**FORD:** 1987-1988 THUNDERBIRD  
1987-1990 CROWN VICTORIA, MUSTANG, BRONCO, E-150, E-250, F-150,  
F-250

### **ISSUE**

Excessive oil consumption on 5.0L EFI engines may be caused by one or more of the following:

## Article No. 90-1-9 Cont'd.

Figure 1 - Article 90-1-9

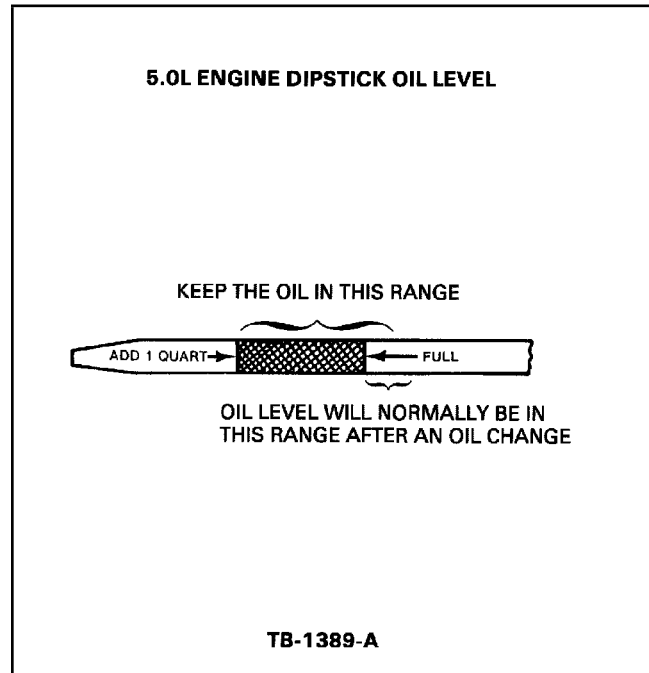
5. Turn the engine off and re-inspect the engine for signs of oil leaks.
6. If an external oil leak is found, repair as required and repeat Steps 4 and 5. If no external oil leak is found, proceed to Step 7.
7. Torque the lower intake manifold using the following two (2) step procedure before proceeding to the "CUSTOMER OIL CONSUMPTION TEST."
  - a. Torque the lower intake manifold bolts in sequence to 15-20 lb.ft. (20-27 N•m).
  - b. Once again, torque the lower intake manifold bolts in sequence to 23-25 lb.ft. (32-34 N•m).

Figure 2 - Article 90-1-9

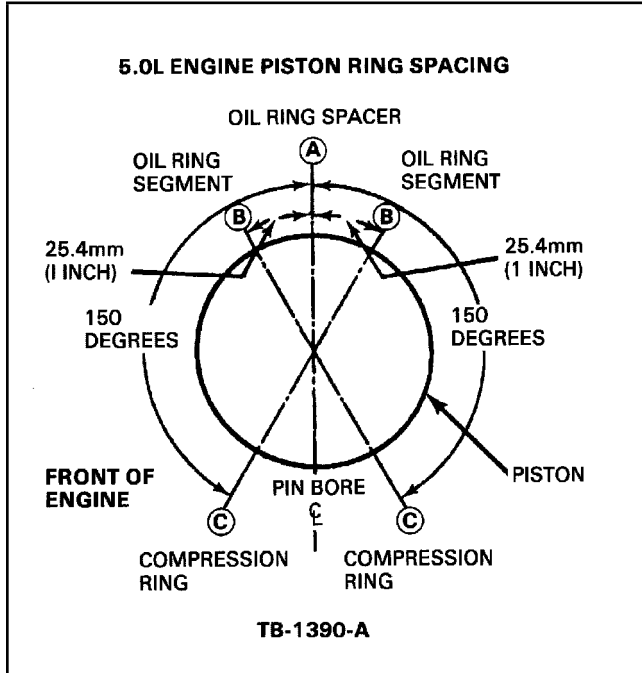
7. Make sure all the connecting rods are marked so they can be re-installed in their original positions.
8. Remove the piston and rod assemblies from the engine.
9. Remove the existing piston rings and throw them away.
10. Install new piston ring sets on each piston. Make sure the ring gaps are properly spaced, Figure 2.
11. Remove the intake and exhaust valve stem seals.
12. Inspect the valve stems to make sure that they are free of nicks and burrs. Repair as required.
13. Install new guide mounted intake and exhaust valve stem seals.
